REMARKS

Application No.: 09/692,073

Docket No.: I2455.0009

Fig 1

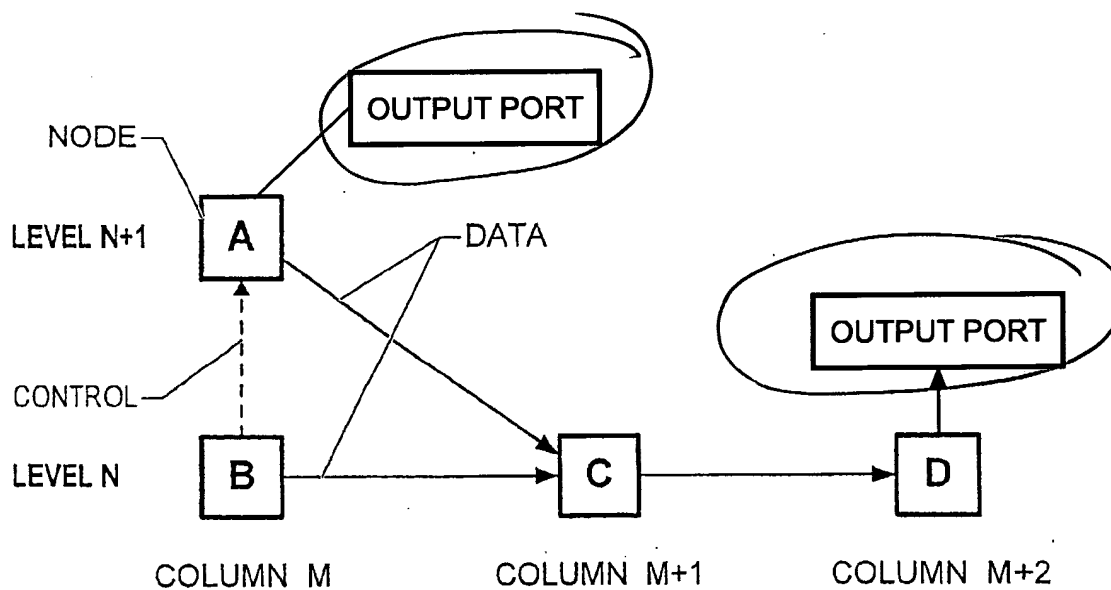
Applicants note that the Figures are objected to for failing to comply with 37 C.F.R. § 1.84(p)(5) because they do not include the following reference signs mentioned in the description such as MA on pages 13 and 14 as well as MA and MB. The Examiner notes that Figures 1, 6B and 6C contain MA and MB but that other Figures that reference these messages in the specification do not contain them. The designators MA and MB refer to messages from node A or node B respectively. As such, one skilled in the art, when reading the specification, would understand that the MA and MB designators do not have to appear in each and every figure for clarity. As such, it is respectfully requested that the Examiner withdraw this objection.

The drawings have been objected to under 37 C.F.R. § 1.83(a). The drawings and specification have been amended in light of the objections. No new matter has been added. As such, Applicants request entering of the drawings and withdrawal of the objections.

Fig 6A

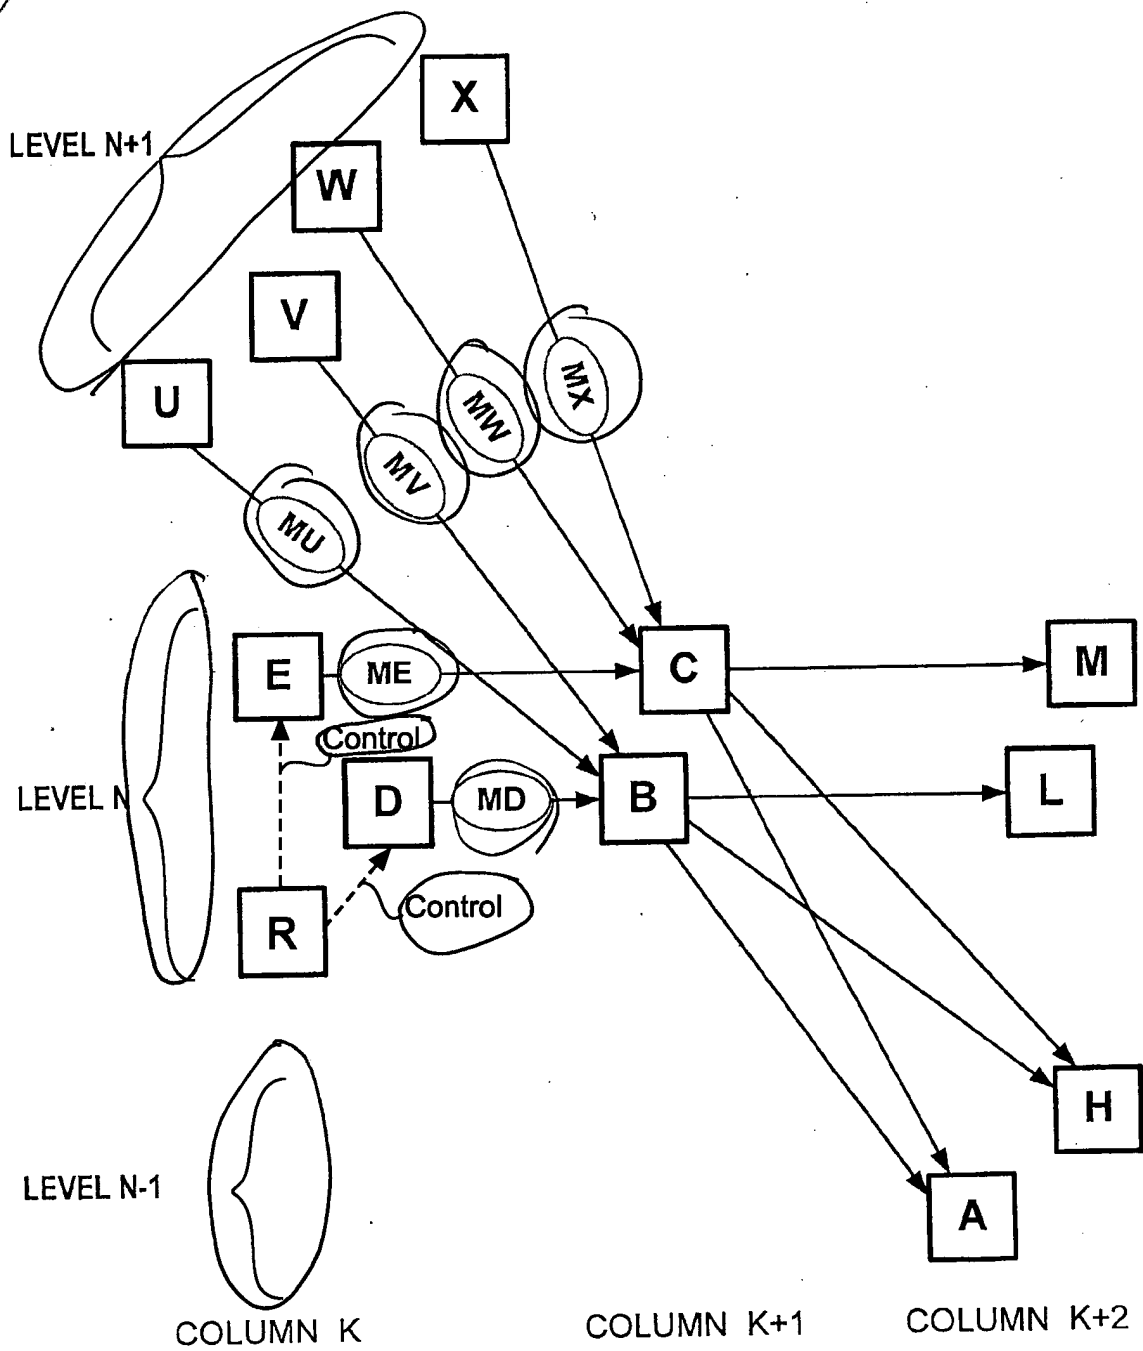
Claim 8 stands rejected because it states “the nodes E, F and H are on a level of the hierarchy directly below the level of the node B.” In Figures 6A and 7, node is shown on the same level as n, as node B. However, within a level a hierarchy can exist as discussed with respect to Figure 8. While E may be on the same level “N” in the hierarchy, it has a lower priority thereby being on a level of the hierarchy below node B. As such, Applicants respectfully request the rejection to claim 8 be withdrawn.
